EXHIBIT "A"

Regarding: Structural engineering inspection and investigation of the three new 8" CMU x 7'-00" tall Screen Walls located at 1840 "E" Street in Lincoln, Nebraska.

KKL No. 28-06

Exhibit "D"

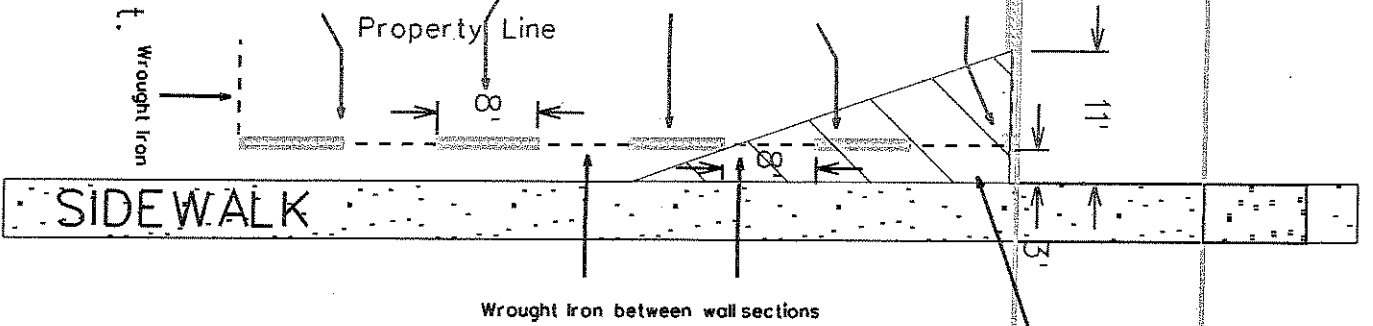
30" Block Wall with
Wrought Iron on Top

6'6" Block Wall
** (Existing Wall to Remain)

30" Block Wall with
Wrought Iron on Top

6'2" Block Wall
** (Existing Wall to Remain)

** NOTE: Must be reinforced and
and inspected by Engineer as
per Structural Engineering Report.
